RESPONSE TO FEDERAL ENERGY REGULATORY COMMISSION (FERC)

Date of Letter: 23.July.2009 / 14.October.2009

HALF-MOON COVE TIDAL BARRAGE / P-12704 / TIDEWALKER ASSOCIATES

FIGURE TIDE-01 / Tidal Range versus Time for Three Modes of Operation

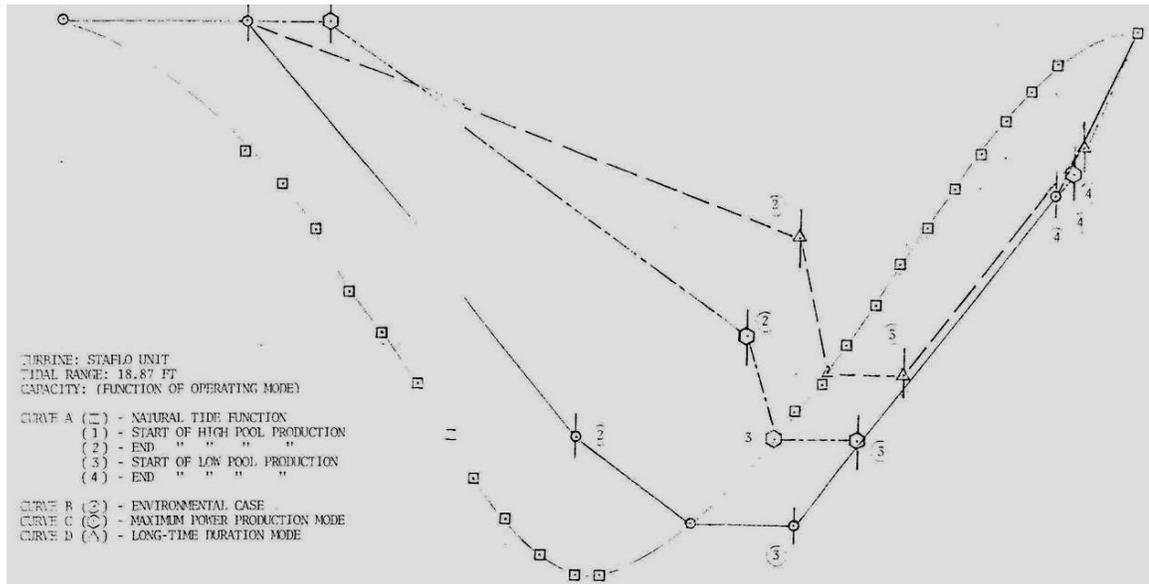
So staff and other participants can effectively evaluate the impacts of the proposed project on the resources of Half Moon Cove and avoid requiring unnecessary studies, please identify a preferred project design and mode of operation.

- A constant head mode of production will be used during both high pool and low pool operation. High pool operation will be initiated approximately one hour after high tide and continue until one hour before low tide. As a conceptual representation, low pool operation will start 1.25 hour after low tide and continue until 1.25 before high tide. A schematic representation of the mode of operation appears in FIGURE TIDE – 01 below. For the proposed Half-Moon Cove barrage, Curve B is the preferred mode of production since it results in less reduction in the natural tidal regime within the impoundment. Curve B is also the representation which most closely resembles the natural tidal function (Curve A) except for the slight shift of approximately one hour on the horizontal scale. The key element of the process for the “environmental” case refers to the ability to completely or nearly empty the tidal basin shortly before or after low tide. Conversely, sufficient gate capacity is needed to completely fill Half-Moon Cove at the cessation of low pool production shortly before the next high tide. Curve D represents the long-time mode of production which would have the most dramatic increase in the level of low tide within the impoundment. Adding pumping capacity to the operational mode of production was considered as a way to completely drain the tidal basin; however, this option is still a possibility depending on the final choice of turbine equipment. If the units are designed to operate at lower hydraulic heads (i.e., between 1’ – 4’), this energy could be used to pump out / in the tidal basin while increasing the length of time for the production of electricity while utilizing residual energy from low-head units.

FIGURE TIDE – 02 / Causeway View

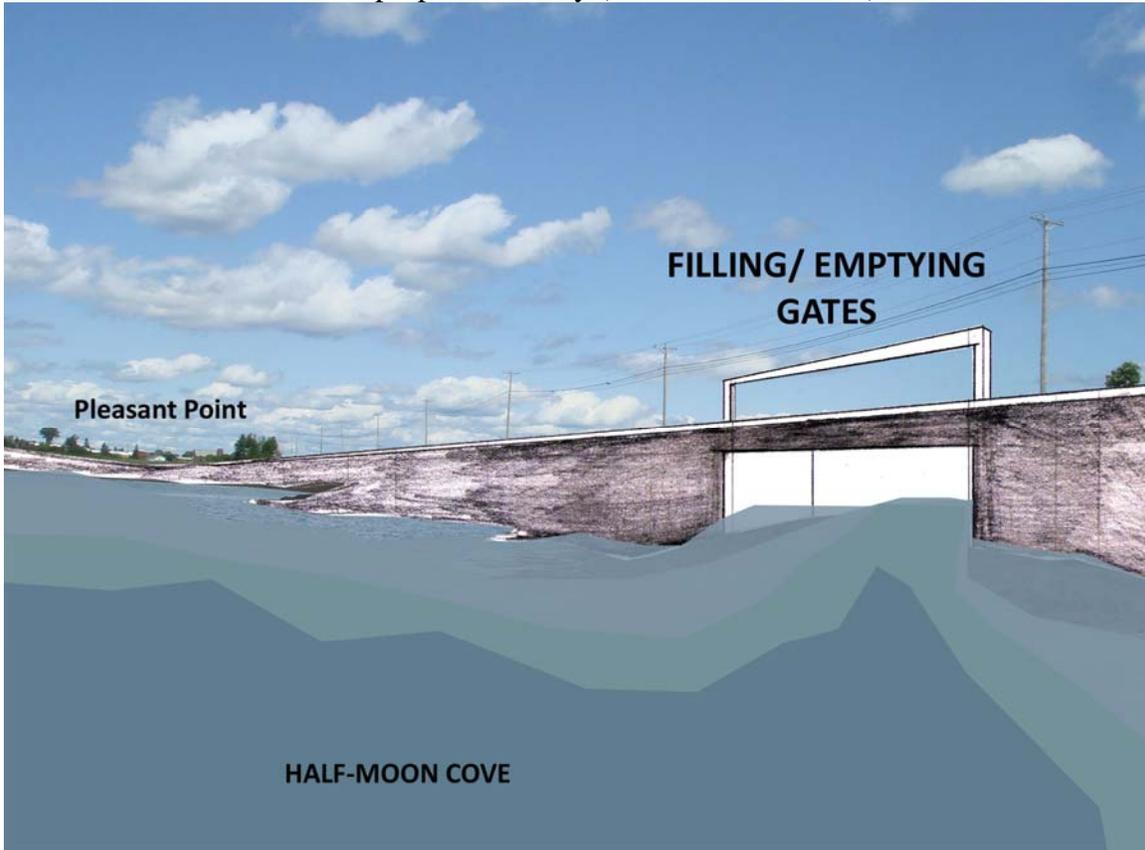
Our preferred mode of production includes provisions to install filling / emptying gates in the causeway between the Passamaquoddy Pleasant Point Reservation and Carlowe

The proposed causeway with emptying / filling gates is illustrated below in an architectural rendition of the proposed facility (FIGURE TIDE – 02):

The size of the gates is expected to be 60' x 20' and will operate from approximately 5' below mid-tide level to 15' above mid-tide level (msl – reference). Operation of the gates will be initiated with the availability of a four foot (or less for neap tides) elevation differential between Passamaquoddy Bay and Half-Moon Cove and will continue until the level of the upper water body falls below mid-tide level. During the Corps of Engineers study on the causeway, a discovery was made that a time differential of approximately 15-30 minutes existed between the respective tidal regimes on both sides of the causeway in question. This phenomenon will be investigated in greater detail during the proposed hydrodynamic modeling of the proposed tidal barrage project. Due to the sinusoidal nature of the tidal function, the elevation difference is more pronounced shortly before and after mid-tide levels on the appropriate side of the causeway.

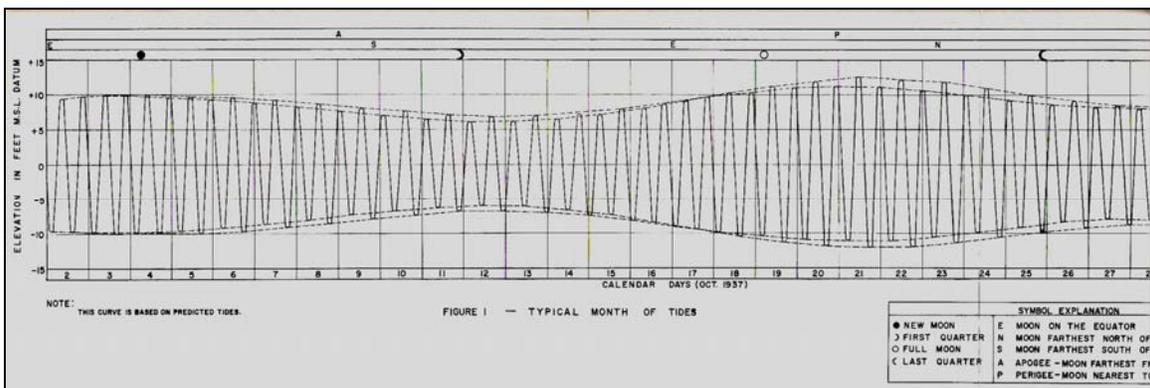
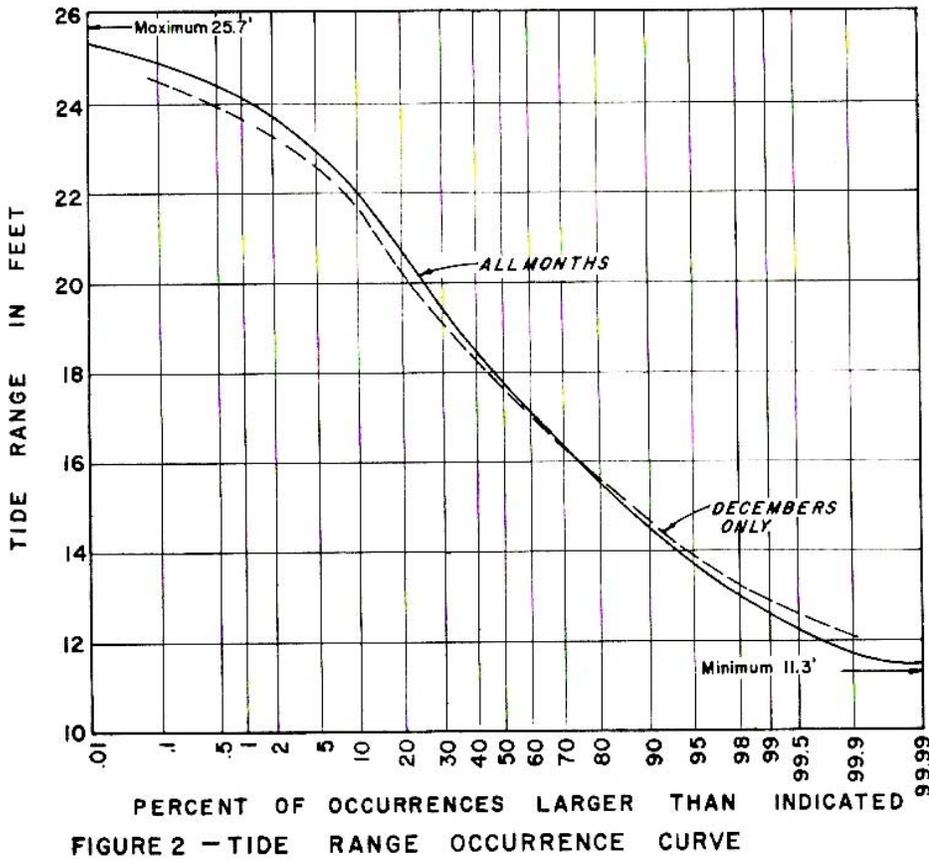
Page 5-3 of the PAD states that the flow duration curve is not a relative function for a tidal power plant. It is unclear, then, how the project's dependable capacity was determined? Please provide the data and the assumptions used to determine the project's dependable capacity. Indicate the period of record and the location of the tide gage(s), including gage identification number(s).

A diagram of the tidal function for the Eastport area is depicted below for one month in a graphical representation of tidal elevation versus time.

Figure 2 above was prepared during an earlier investigation of tidal power in Passamaquoddy Bay and Cobscook Bay. Figure 2 essentially represents a flow duration curve to reflect differences between predicted and actual tidal range values. In selecting an installed capacity for the tidal barrage, the root-mean-square value of the tidal ranges (i.e., 18.9 feet) was used for engineering calculations. A previous section of this response contains an explanation on selecting an appropriate installed capacity. The procedure for calculating installed capacity for a tidal barrage is substantially different than the process used for a “run-of-river” hydro-electric facility since tidal flows are predictable in both time and intensity. A tidal barrage is essentially a “run-of-tide” facility which controls potential energy within a relatively narrow band of tidal flows to levelize production during the range from neap tide to spring tide conditions.
